Solicitation No. 3450035790

Amendment No. 1

**BRYAN COUNTY
MAINTENANCE FACILITY**

REVISION SUMMARY – ADDENDUM #01

SHEET NAME
SITE PLAN
SHEET
C3.1

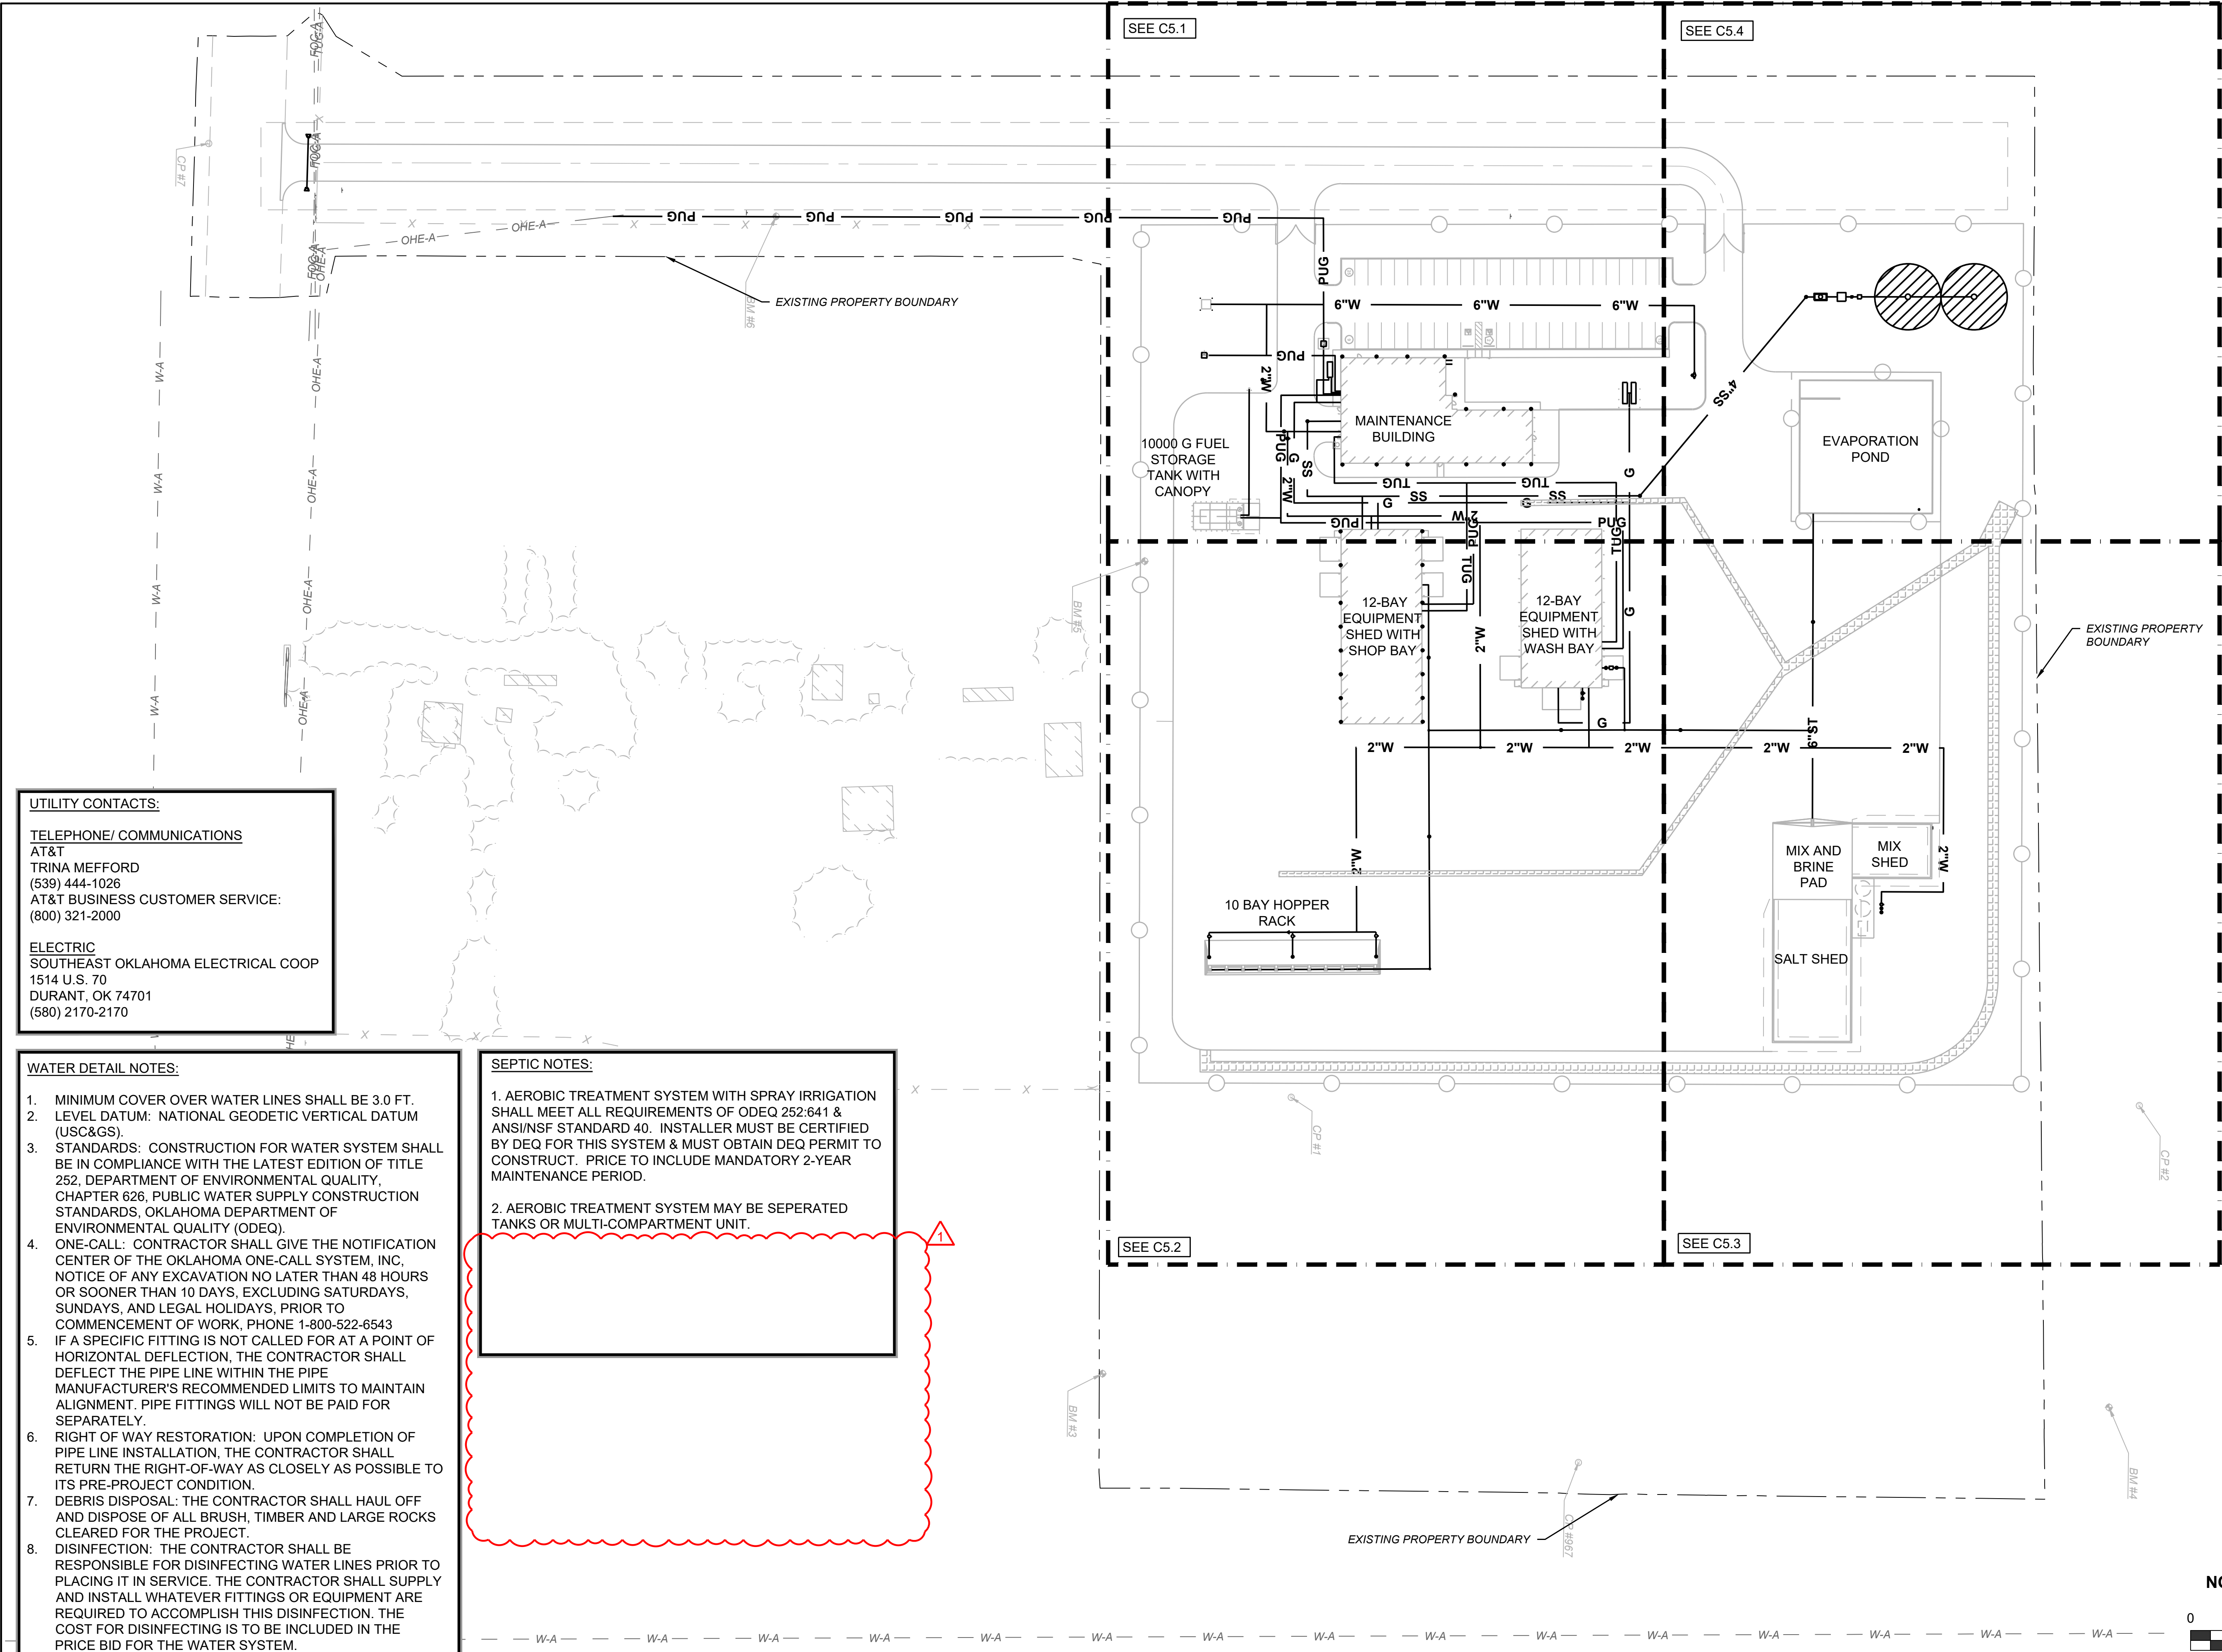
Q 9: What is the surface under the two propane tanks? (C3.0)

1. UPDATED NOTE FOR PROPANE TANK AREA.

A 9: Contractor provides and installs tanks with an adequate concrete foundation.

SHEET
C5.0

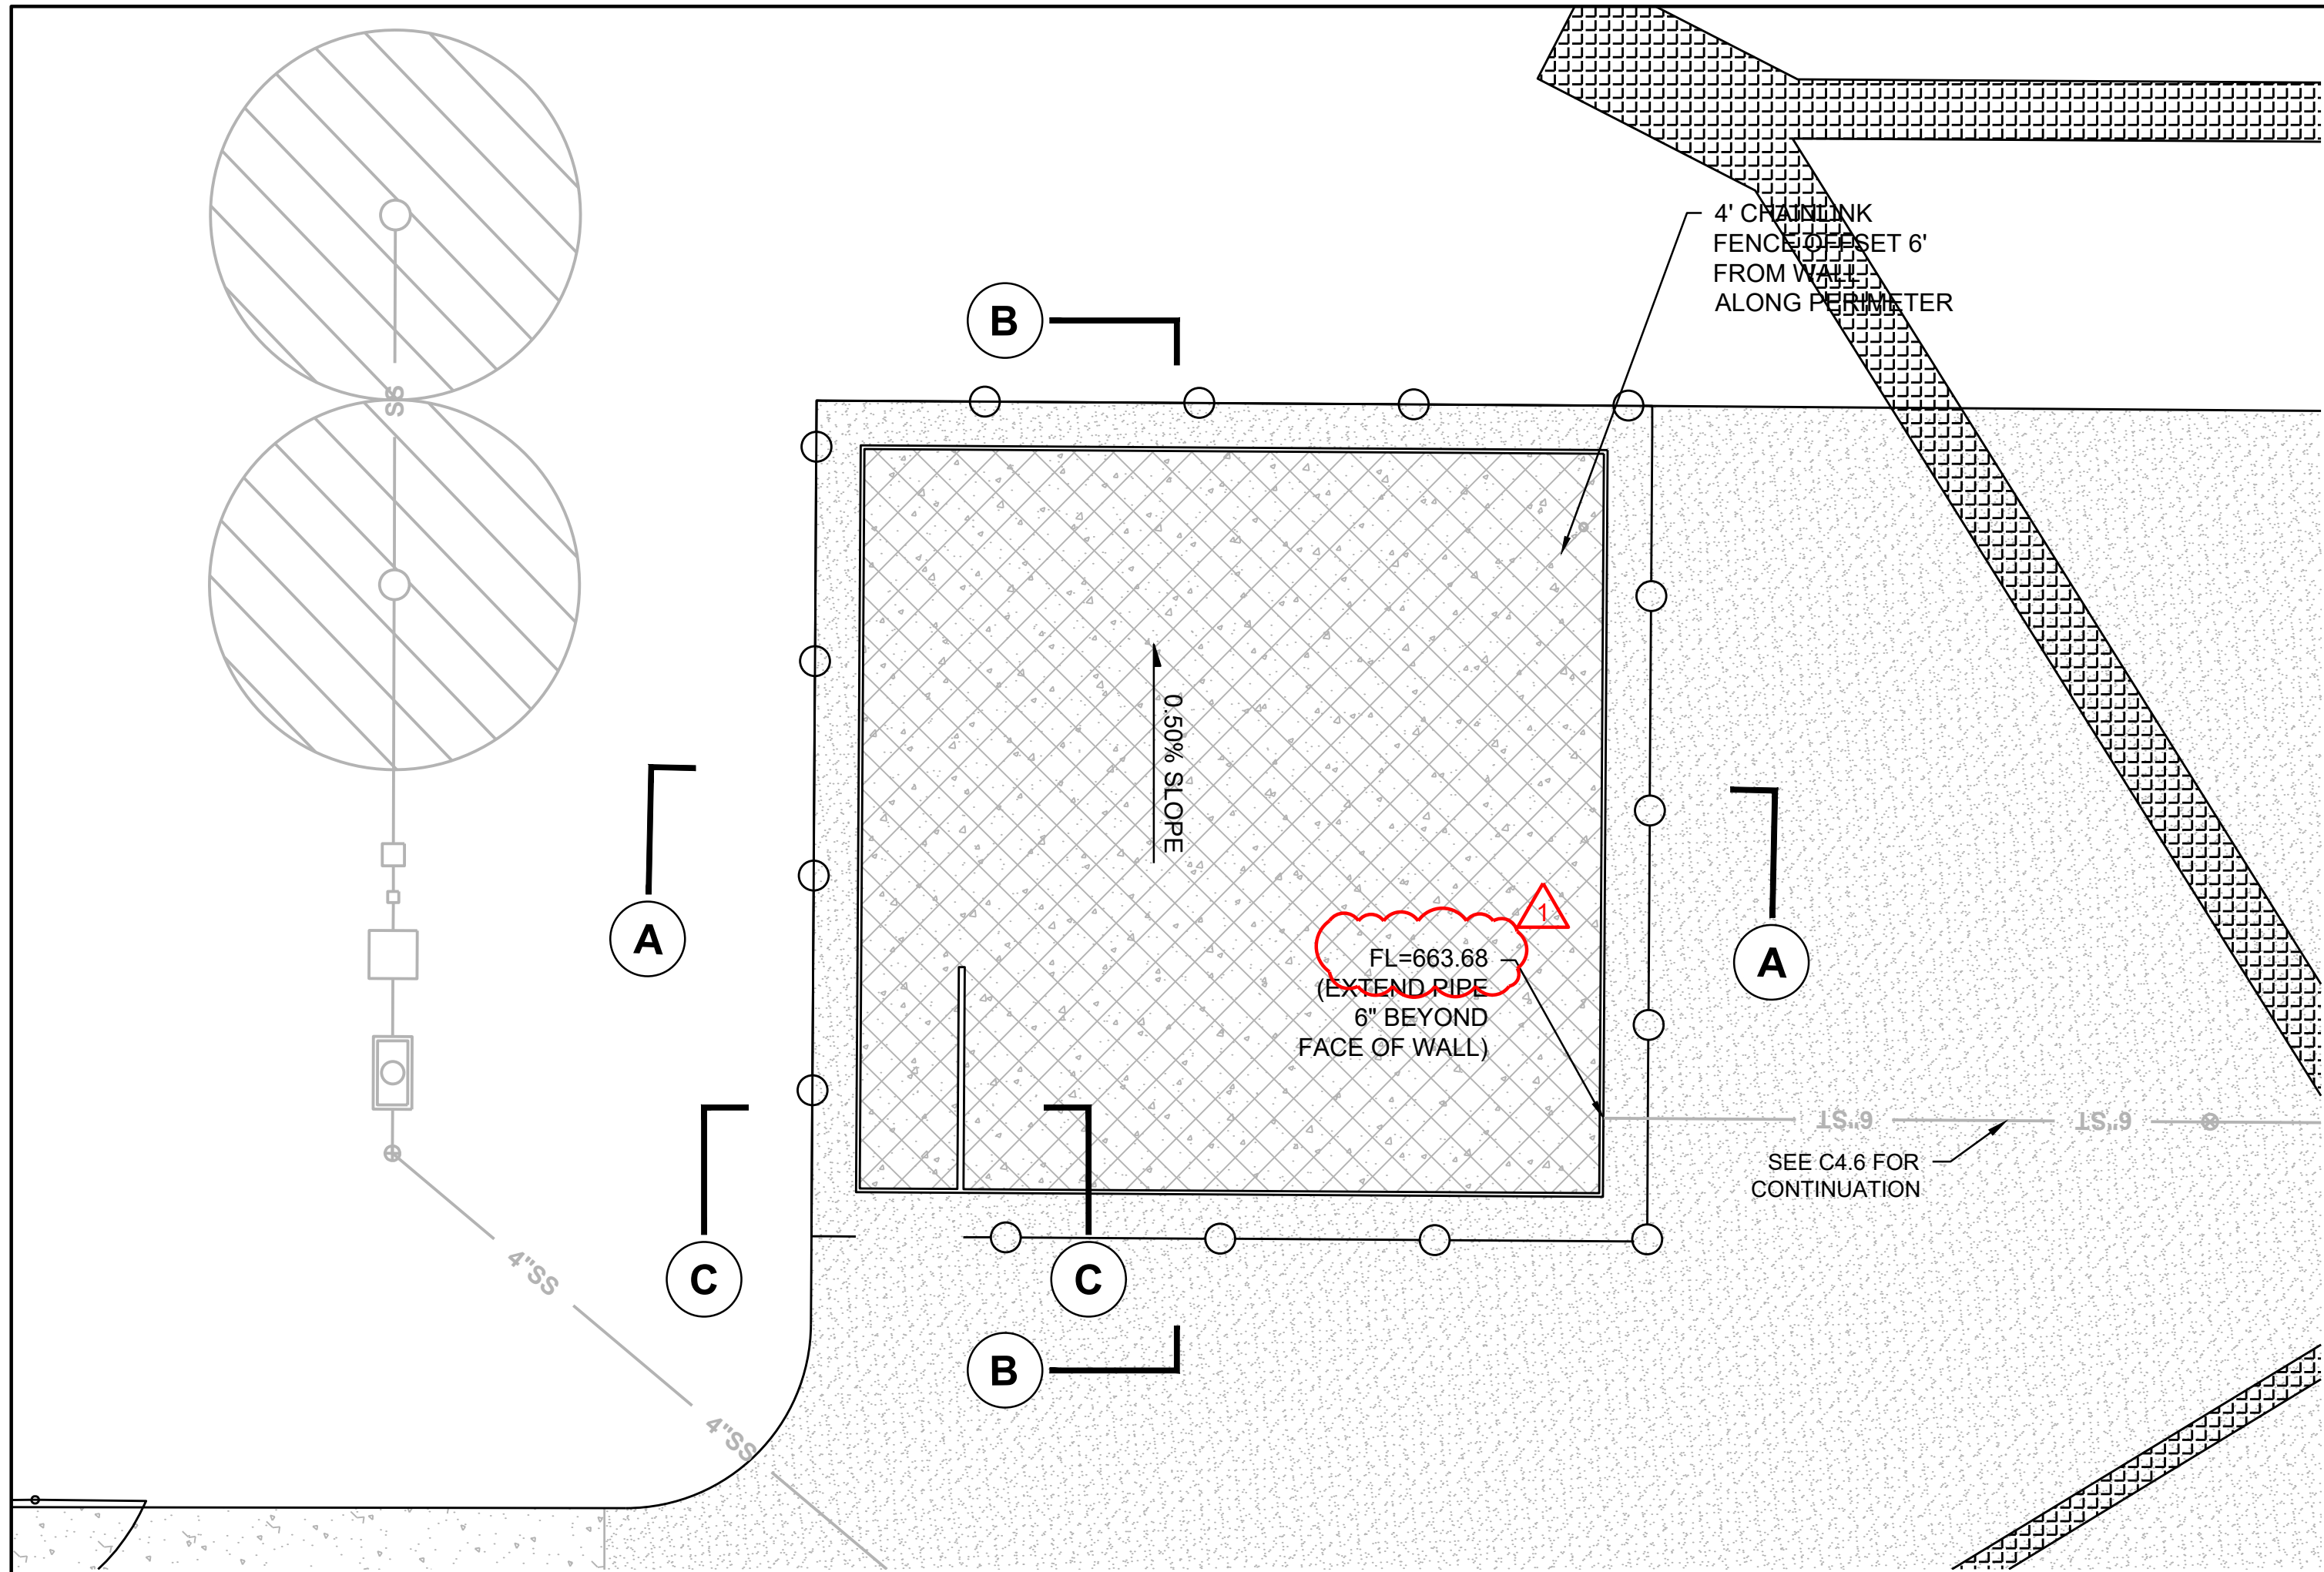
Q 19: Please clarify if the contractor provides the light pole or ODOT (C5.0).

1. REMOVED NOTES ABOUT USING ATTIC STOCK FOR LIGHT POLES

A 19: Contractor provides the poles.
